#### BPC Central Small Diameter Package 1 Solicitation Number: CO-00293-FF Job No.: 18-4532

### **ADDENDUM 02** August 21, 2019

SUMMARY OF QUANTITIES

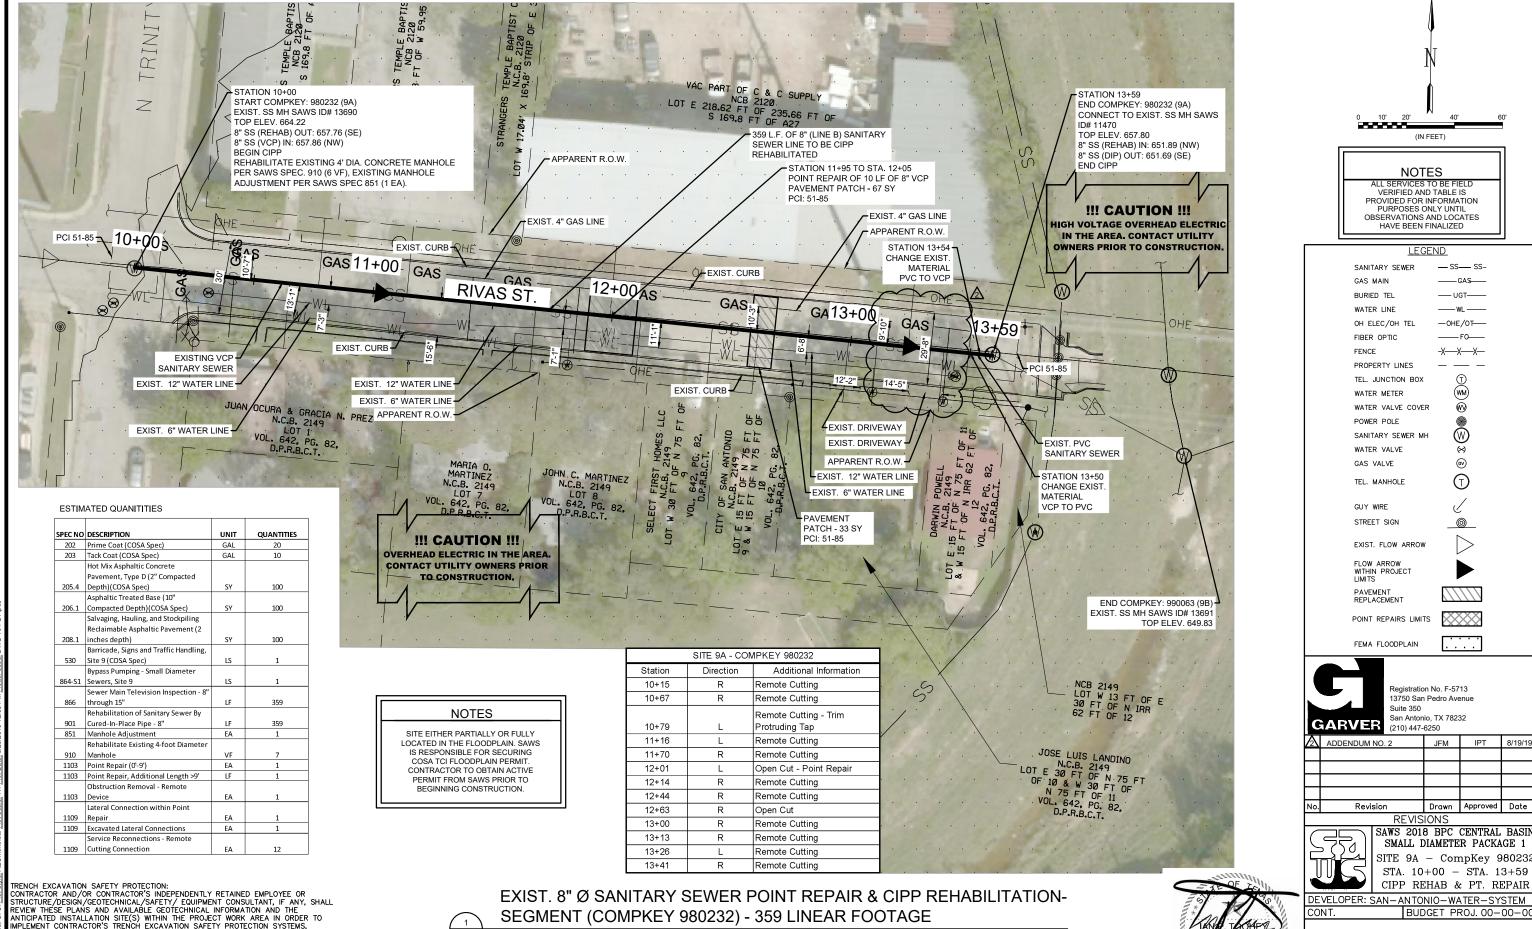
- Updated Summary of Quantities.
- 4. Sheet 15- Remove Sheet 15 and replace with revised Sheet 15 attached to this Addendum.
  - Updated Alignment based on Test Hole Information.

SMALL DIAMETER PACKAGE 1 SITE 9A - CompKey 98023

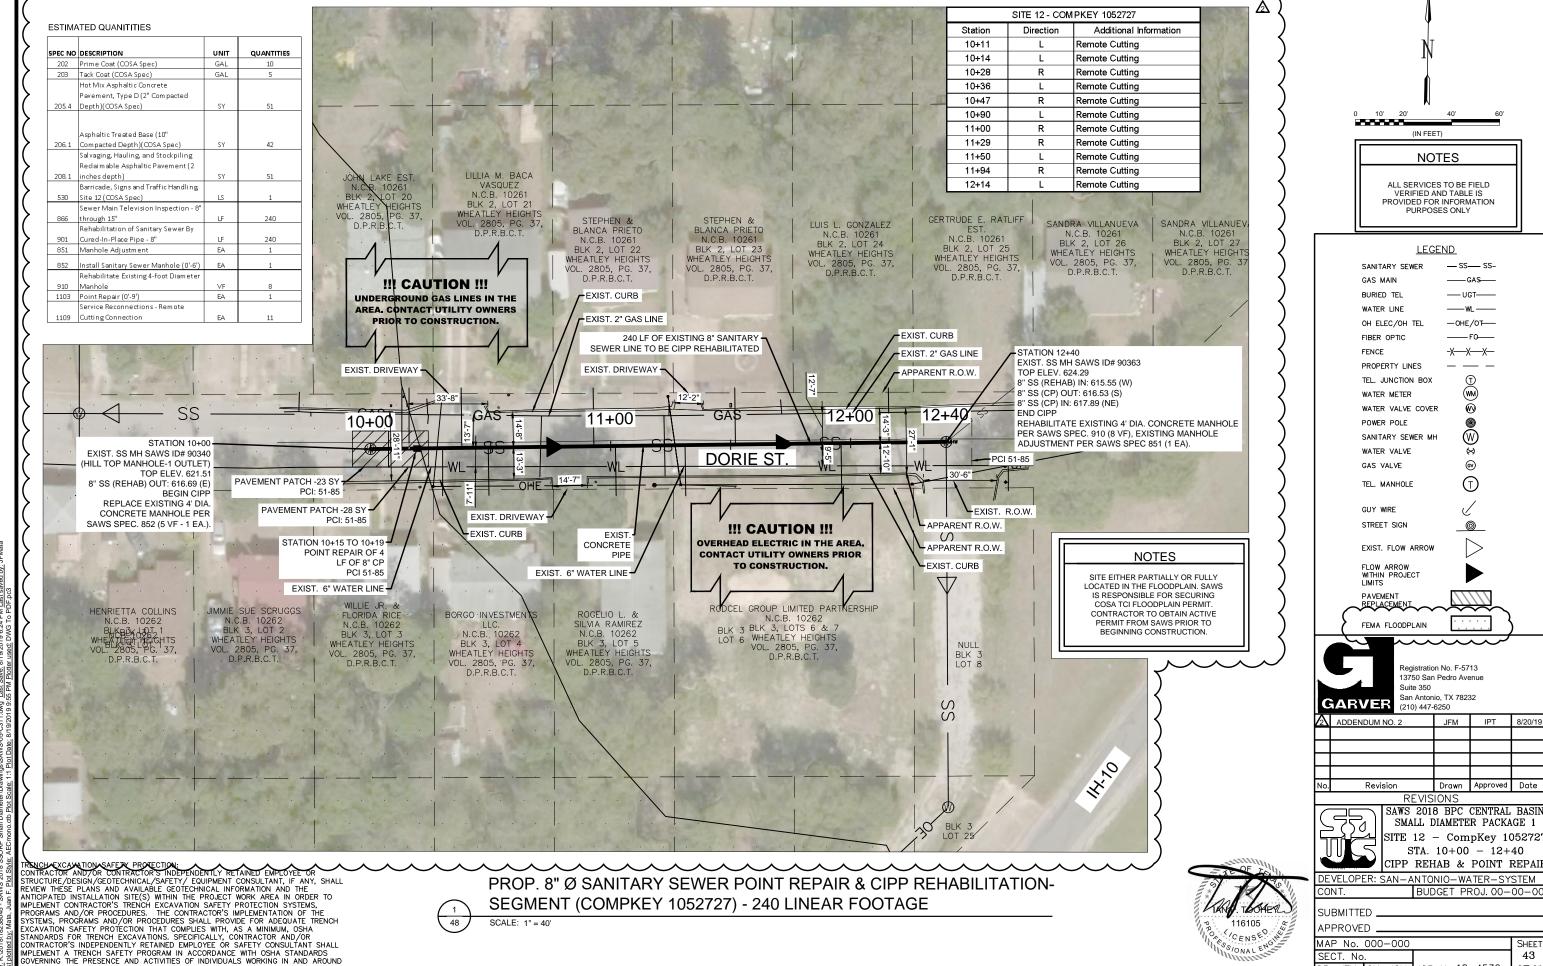
- 5. Sheet 32- Remove Sheet 32 and replace with revised Sheet 32 attached to this Addendum.
  - Edited visibility of curb to curb dimension (29'-8") of Rivas St. as shown between Sta 13+00 and 13+59. No substantial changes to proposed improvements and/or quantities.

48

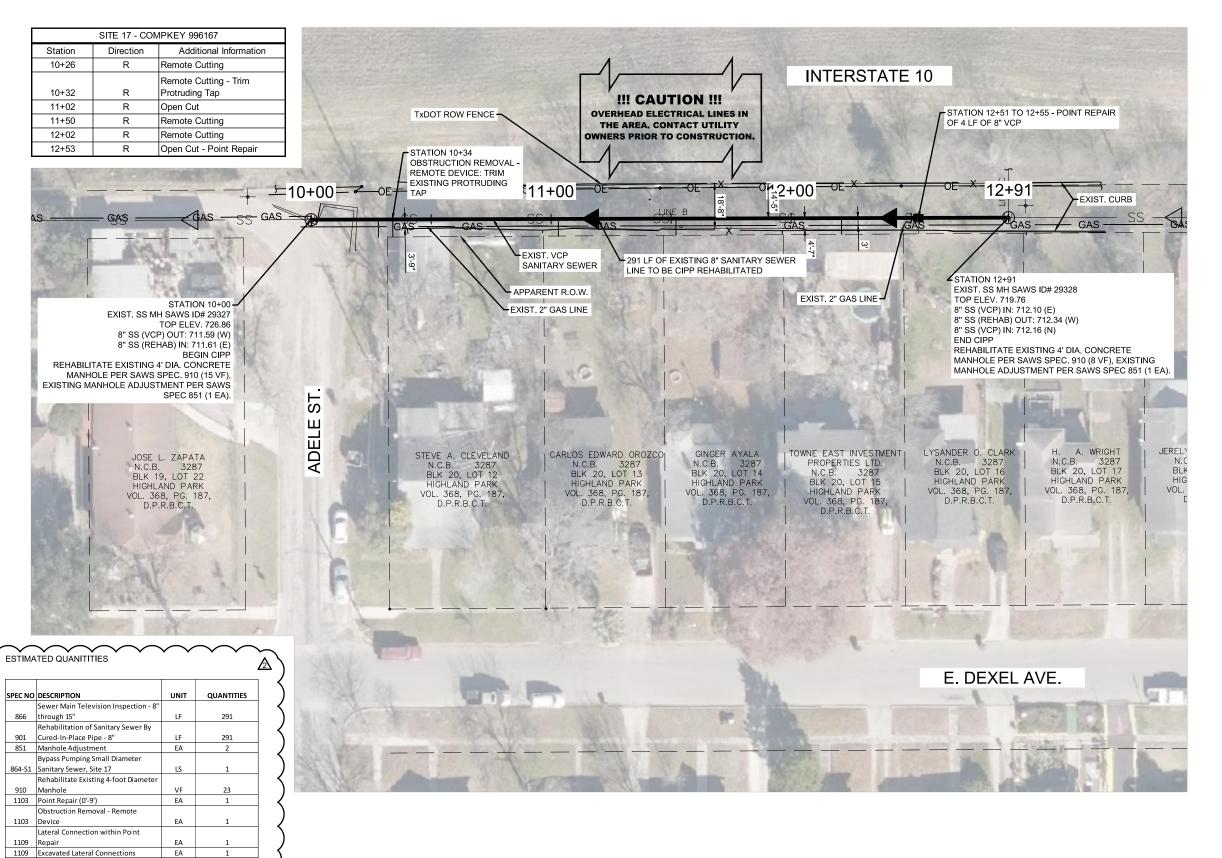
- 7. Sheet 48- Remove Sheet 48 and replace with revised Sheet 48 attached to this Addendum.
  - Updated Alignment based on Test Hole Information.
  - Updated stations and services with relocated alignment.

SAWS 2018 BPC CENTRAL BASIN SMALL DIAMETER PACKAGE 1 SITE 17 – CompKey 1065052

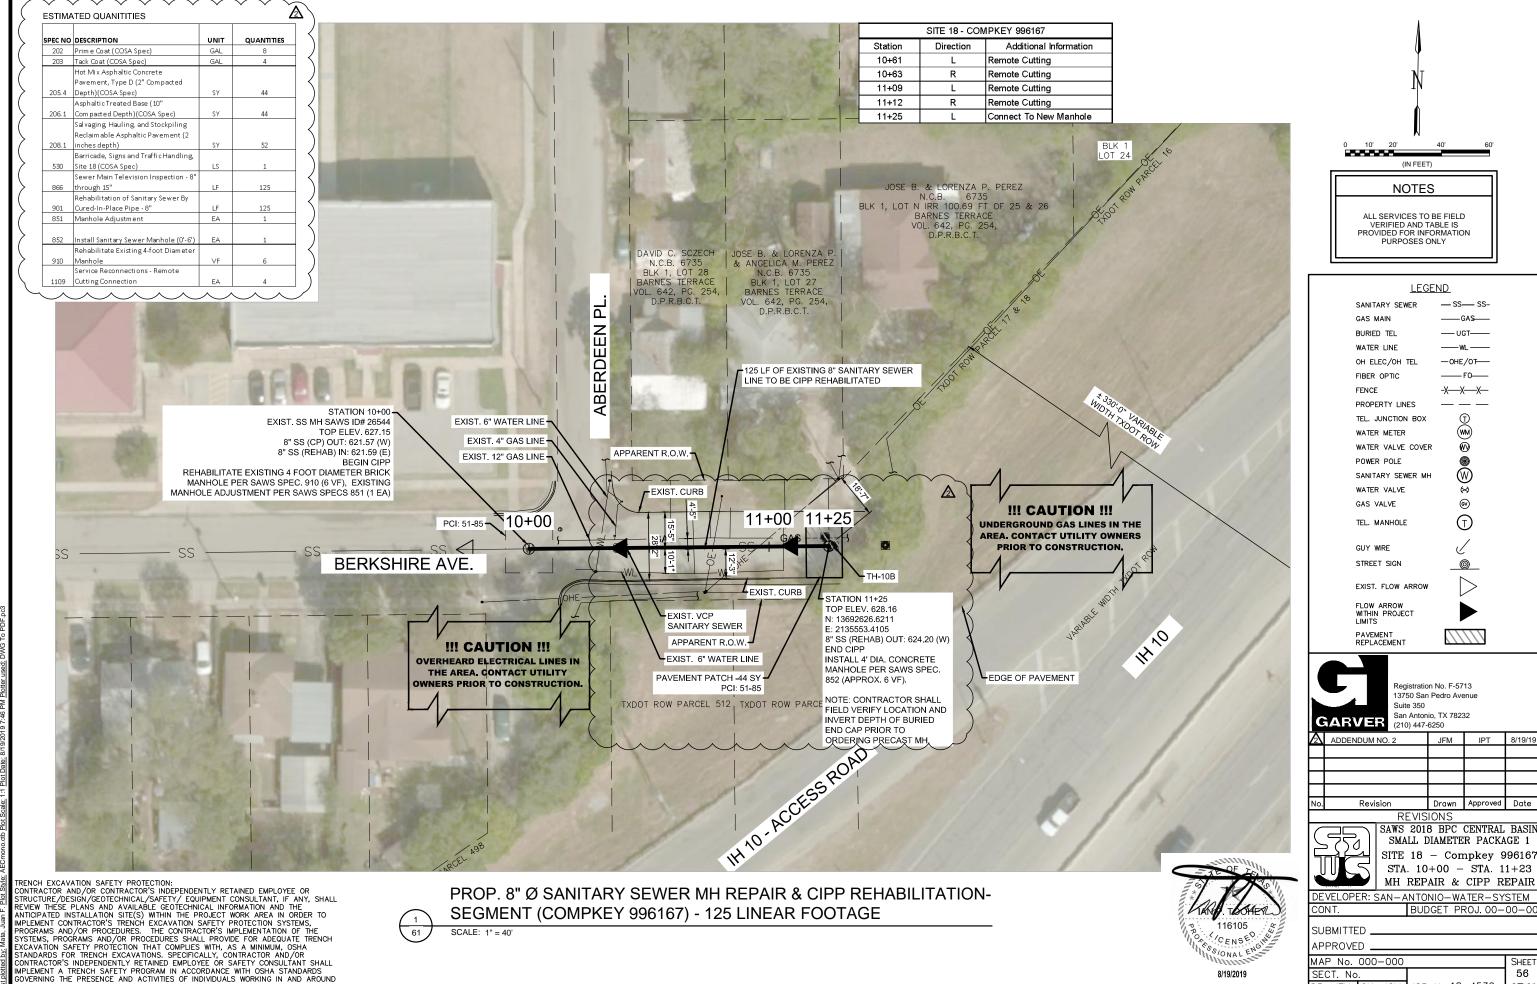
4. There is no table of Estimated Quantities included on drawing sheet 54 for Site 17 or drawing sheet 79 for Site 23. Please provide the table of Estimated Quantities for these sites.

- **8.** Sheet 54- Remove Sheet 54 and replace with revised Sheet 54 attached to this Addendum.
  - Updated Estimated Quantities Table- Added Bypass pumping line item to quantity table.

Answer: These tables are included in the bid set. On Sheet 54, the table is on the bottom left corner. On Sheet 79, the table is on the upper left corner. Please see Changes to the Plans Items No. 7 and 9.
